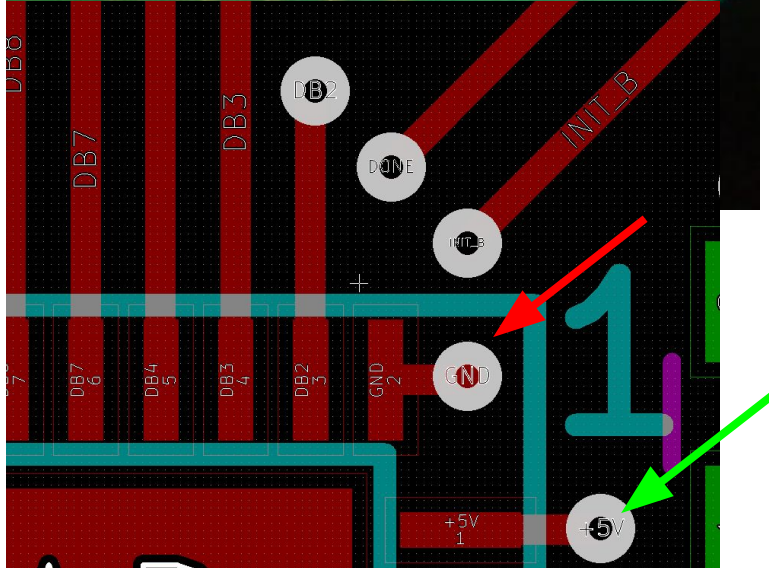
- Remove the annular ring of via connected to pin 2 of U22 (in red).
- Connect pin 2 of U22 to +5V via connected to pin 1 of U22 (in green)
- Remove R135 and R136

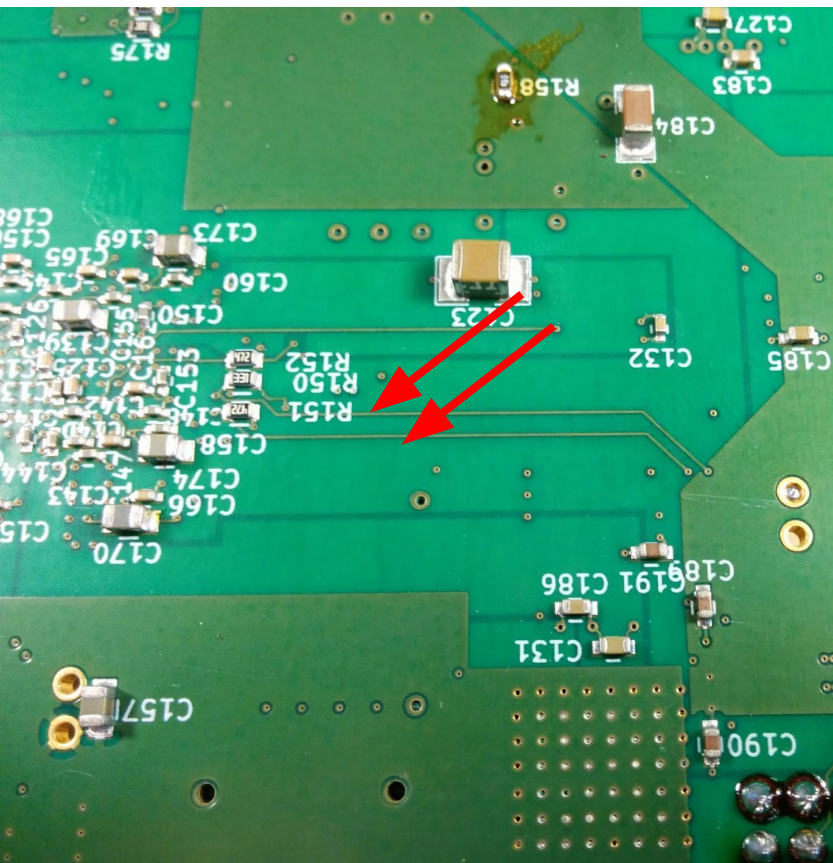
- Cut two marked traces on back side of board

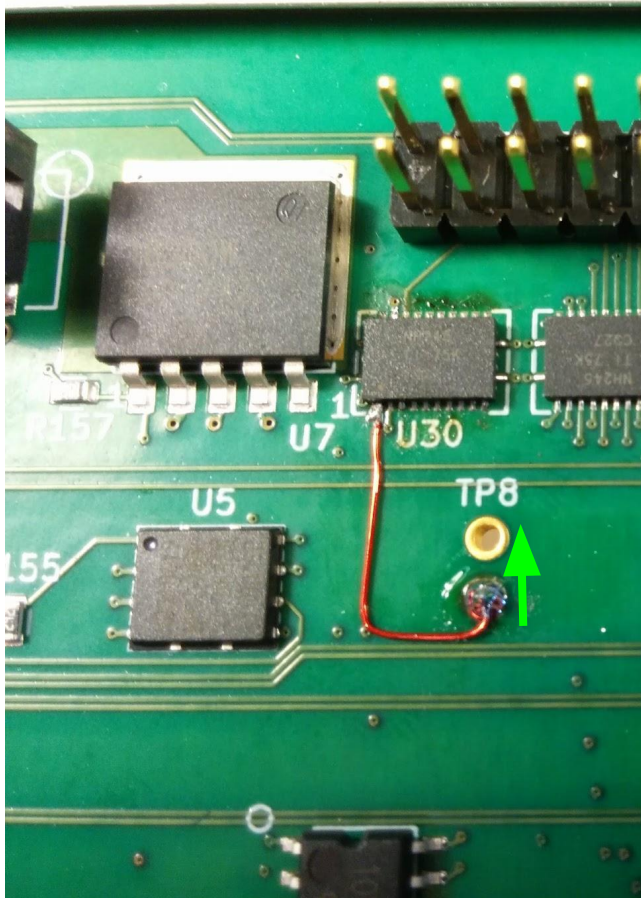
- Move ECO wire from lower to upper through-hole of TP8
